PCN#20160920005
Carrier Tape Change for Select devices in the 20L SOP Package
Final Change Notification

PCN Number:	20160920005	PCN Date:	Sept. 29, 2016
Title:	Carrier Tape Change for Select devices in the 20L SOP Package		
Customer Contact:	PCN Manager	Dept:	Quality Services
Proposed 1st Ship Date:	Dec. 29, 2016		
Change Type:			
<input type="checkbox"/>	Assembly Site	<input type="checkbox"/>	Assembly Process
<input type="checkbox"/>	Design	<input type="checkbox"/>	Electrical Specification
<input type="checkbox"/>	Test Site	<input checked="" type="checkbox"/>	Packing/Shipping/Labeling
<input type="checkbox"/>	Wafer Bump Site	<input type="checkbox"/>	Wafer Bump Material
<input type="checkbox"/>	Wafer Fab Site	<input type="checkbox"/>	Wafer Fab Materials
<input type="checkbox"/>		<input type="checkbox"/>	Part number change
<input type="checkbox"/>		<input type="checkbox"/>	Assembly Materials
<input type="checkbox"/>		<input type="checkbox"/>	Mechanical Specification
<input type="checkbox"/>		<input type="checkbox"/>	Test Process

Carrier tape Dimensions :

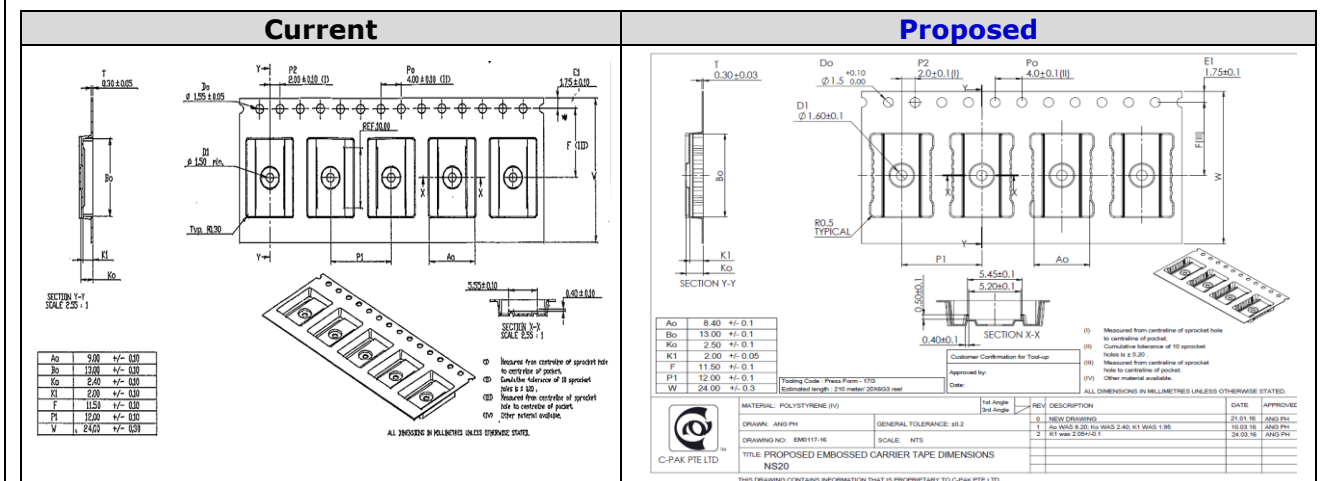
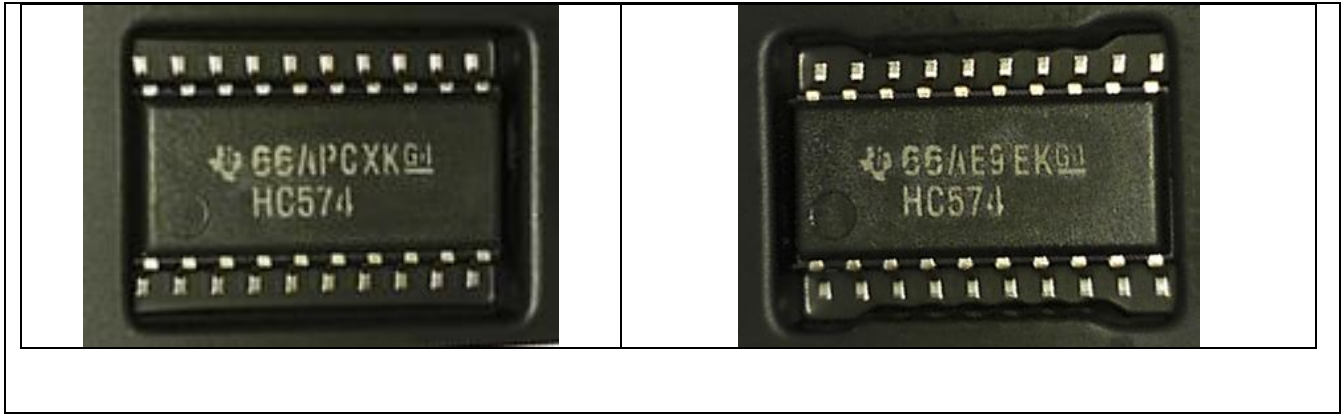
Texas Instruments is pleased to announce the qualification of a new carrier tape for select devices in the 20L SOP package. The material composition, supplier, and color between the 2 carrier tapes are the same. A dimensional comparison summary is below:

Dimension	From	To
Ao	9.00 (+/- 0.1) mm	8.40 (+/- 0.1) mm
Bo	13.00 (+/- 0.1) mm	13.00 (+/- 0.1) mm
Ko	2.40 (+/- 0.1) mm	2.50 (+/- 0.1) mm
K1	2.00 (+/- 0.05) mm	2.00 (+/- 0.05) mm
F	11.50 (+/- 0.1) mm	11.50 (+/- 0.1) mm
P1	12.00 (+/- 0.1) mm	12.00 (+/- 0.1) mm
W	24.00 (+/- 0.3) mm	24.00 (+/- 0.3) mm
